QUAD CITIES NUCLEAR POWER STATION UNIT NO. 1

AMENDMENT TO FACILITY OPERATING LICENSE

Amendment No. 69 License No. DPR-29

By letter dated May 22, 1978, Commonwealth Edison Company (the licensee) proposed that the Quad Cities Unit 1 and 2 Technical Specifications be amended to remove reactor water cleanup system isolation valve MO-1201-80 from Table 3.7-1, <u>Primary Containment Isolation</u>, and exclude the valve from the surveillance described in Section 4.7.D.

3.7/4.7-21

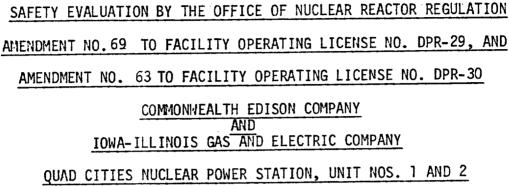
We have reviewed the reactor water cleanup (RWCU) system to determine if the return valve MO-1201-80 should be included in Table 3.7-1 as one of the listed primary containment isolation valves (PCIV's). Table 5.2.4 of the FSAR indicates that the RWCU return line enters the primary containment (PC) thru penetration X-15, provided for that purpose. According to the licensee, the original plant design called for valve 1201-80 (the valve under consideration) to be located in the return line just outboard of the PC, and check valve 1201-81 to be located just inboard of the PC. Valve MO-1201-80 would then be Class A PCIV. It is presently listed as such in Table 5.2.4 of the FSAR and is listed in Table 3.7-1, <u>Primary Containment Isolation</u>, in the Technical Specifications for each unit.

As the plant is built, however, and as shown in drawings M-47 and M-15 of the P and ID's for the Quad Cities units, the RWCU return line does not penetrate containment thru penetration X-15, but instead is routed via valve 1201-80, check valve 1201-81, and manual valve 1201-82 into the "A" feedwater line. (This configuration has been confirmed by discussions with the Resident Inspector). The RWCU return line then enters the PC via check valve 220-62A, penetration X-9, check valve 220-58A, and then into the reactor via feedwater spargers. It is seen that MO-1201-80 is not a PCIV and should not be listed as such in the Technical Specifications.

No modification will be made to the automatic function for valve MO-1201-80. Valve closure will still be initiated by low water level, SBLC initiation, or high temperature in the non-regenerative heat exchanger outlet. The special surveillance requirements to be performed for PCIV's will however not apply to valve MO-1201-80. On the basis of the foregoing evaluation, the licensee's proposal to exclude valve MO-1201-80 from Table 3.7-1 of the Technical Specifications is acceptable.
